ALPINE CITY PLANNING COMMISSION MEETING

SUBJECT: Review of the Five.12 Commercial Site Plan

The Five.12 Commercial Site Plan is proposed for the address of 168 S Main Street in Alpine and proposes a new commercial building. The building is to support their ongoing operational needs and provide more space for their non-profit ventures. Since the Planning Commission meeting on June 2nd, the applicant has updated their building design with the purpose of trying to meet the Historic/Gateway Design Guidelines.

SITE PLAN

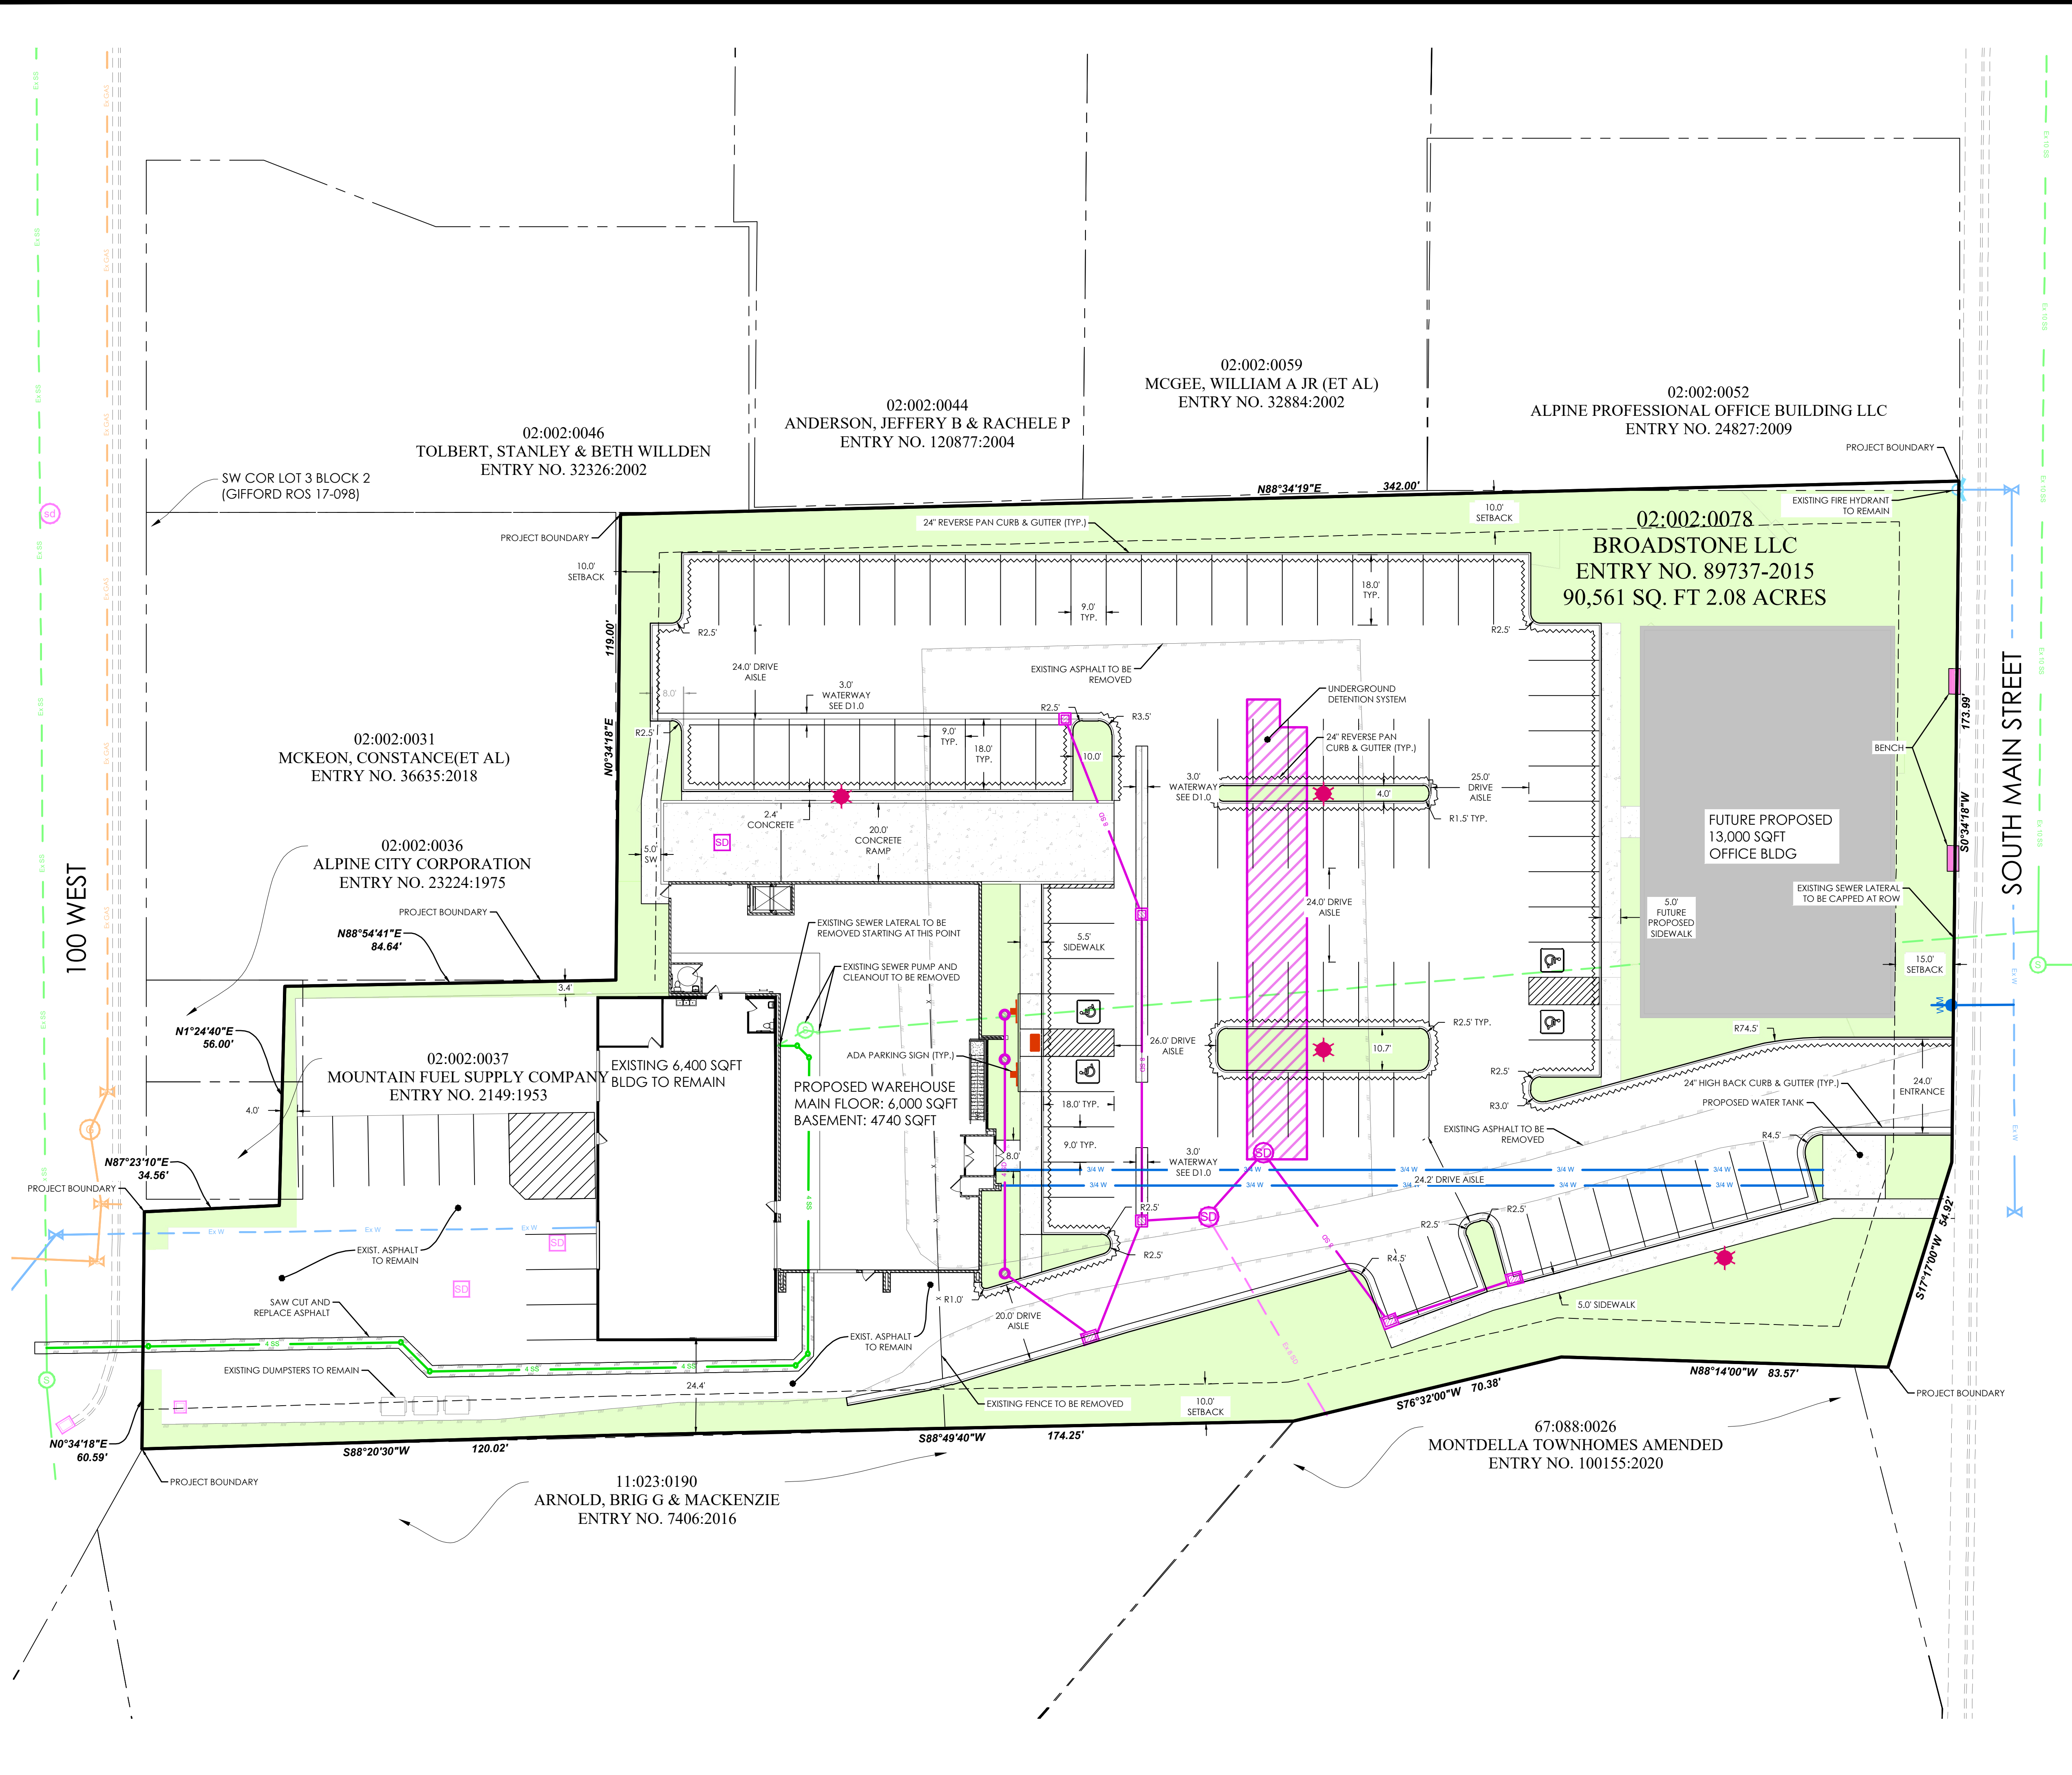
The applicant has provided a site plan that overall meets the code requirements for §3.06 Business Commercial Zone and §3.11 Gateway/Historic Zone. The building takes on an industrial look with dark brick and black metal trims and accents to complement the main material. The landscaping requirement of 20% coverage of the site is currently being met, but any new building might cause the site to fall out of compliance with that requirement. A few streetscape elements every thirty (30) feet would be needed along the sidewalks. There is a water tank proposed for the site which will have to be evaluated for compliance at a later date, and likely will require a building permit and might need to meet accessory structure setback standards. Since this needs further evaluation, it should be labeled as “future proposed water tank.”

Staff recommends that the Planning Commission consider sending a positive recommendation to the City Council for the proposed site plan for the new Five.12 commercial building at 170 S Main Street, with the condition that the streetscaping requirements be met and that the proposed water tank be labeled as “future proposed water tank” on the site plan.
